AS BUILT PLANS
 Contractor: McCullough Excavation
 Inspector: Larry Powell, Baughman co.
 As Built by: KEK, 2/7/22

WATER DISTRIBUTION SYSTEM to serve **RED ROBIN**

7355 W. TAFT ST.
 CITY OF WICHITA, KANSAS

LINE 1

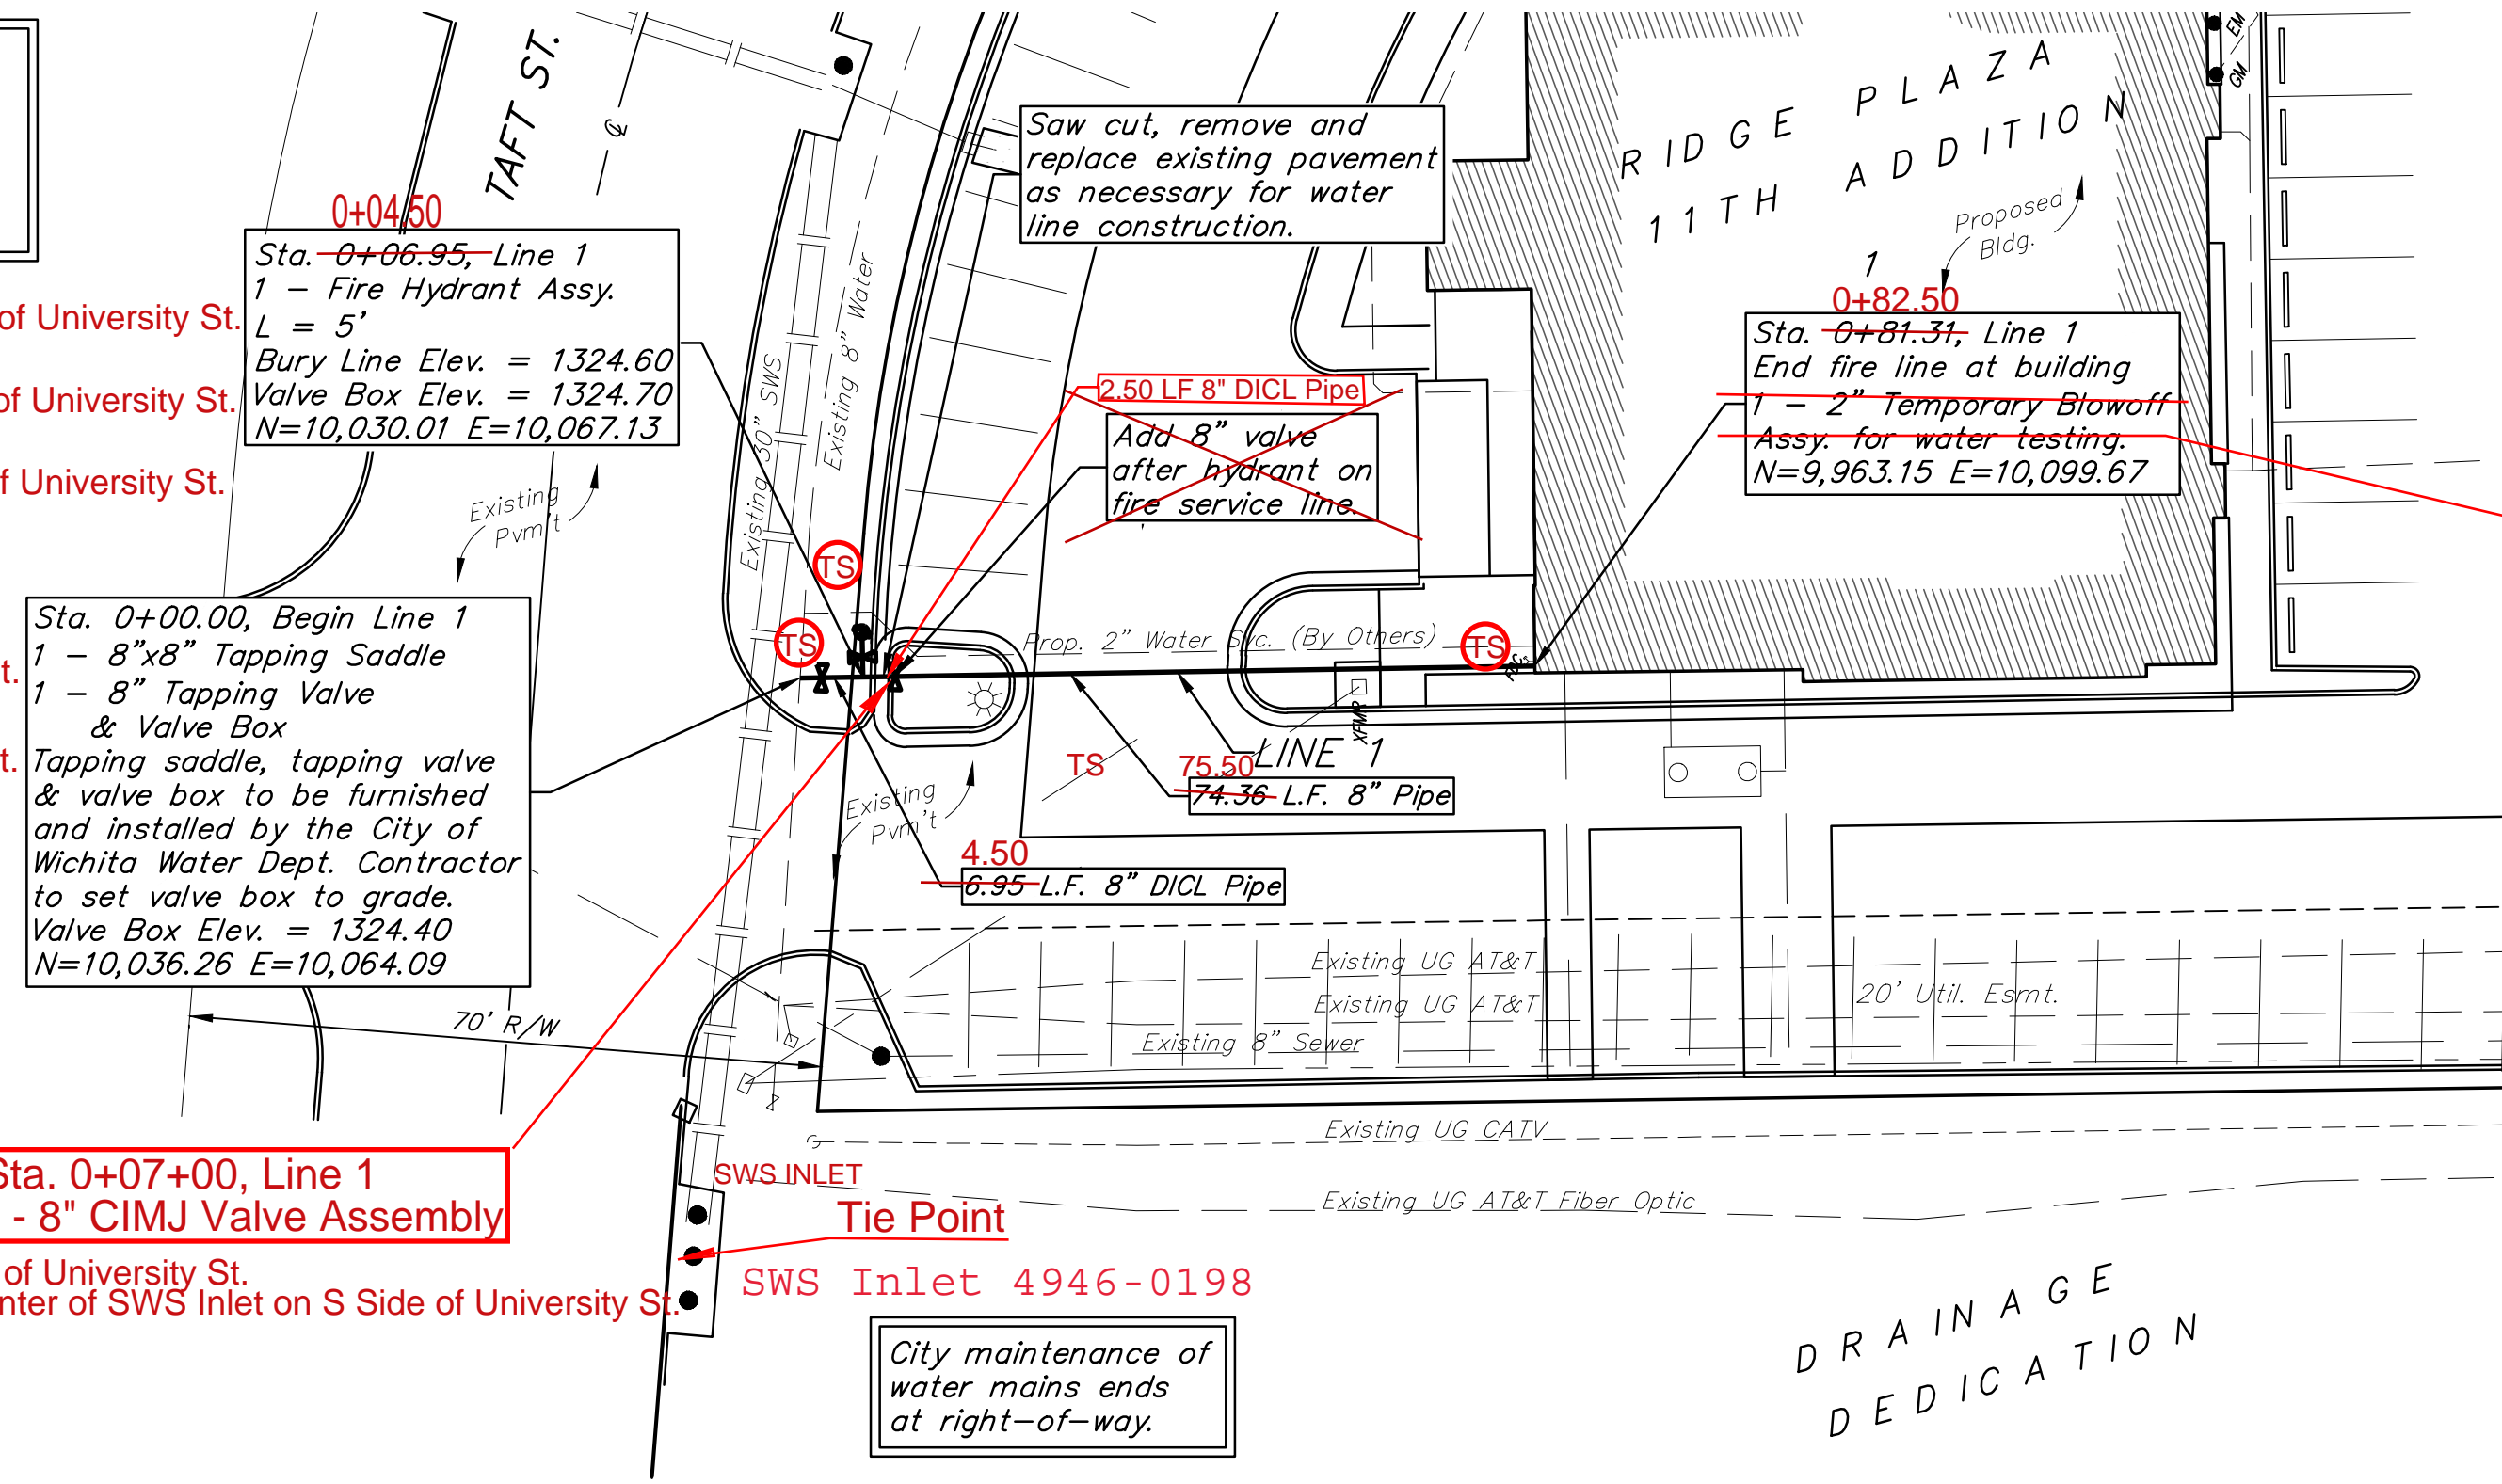
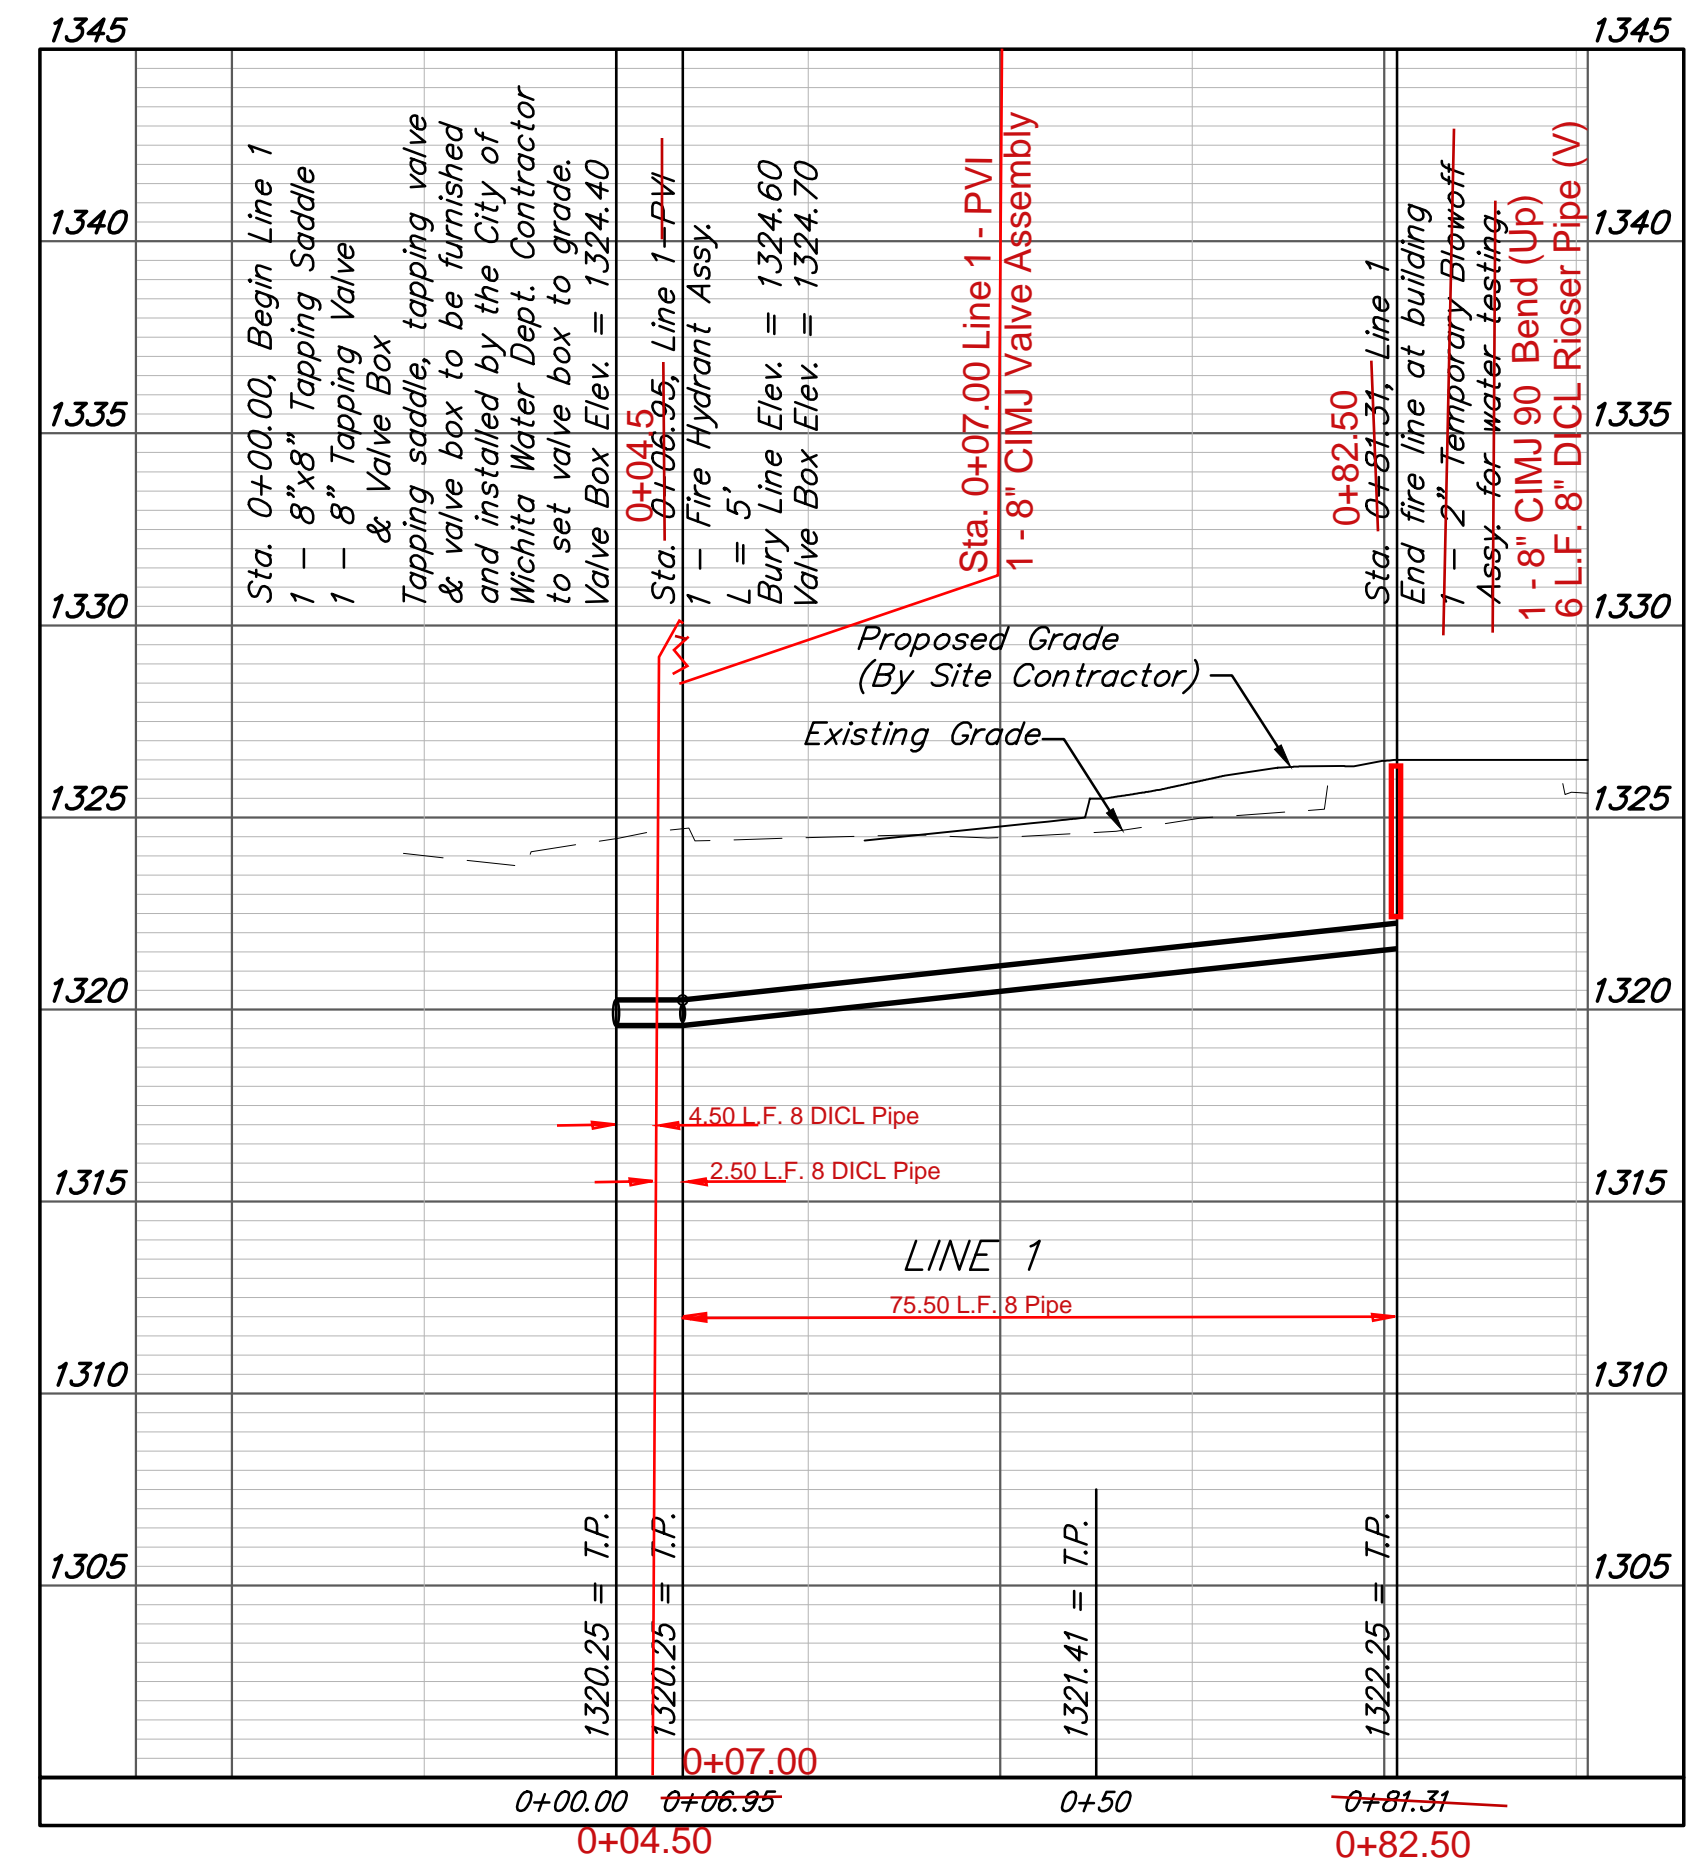
Tee is 37' S of the CL of University St.
 66' E of the Center of SWS Inlet on S Side of University St.
 Valve is 37' S of the CL of University St.
 68' E of the Center of SWS Inlet on S Side of University St.
 Fire Hydrant is 37' S of the CL of University St.
 71' E of the Center of SWS Inlet on S Side of University St.

Tee is 32' S of the CL of University St.
 66' E of the Center of SWS Inlet on S Side of University St.
 Valve is 34' S of the CL of University St.
 66' E of the Center of SWS Inlet on S Side of University St.
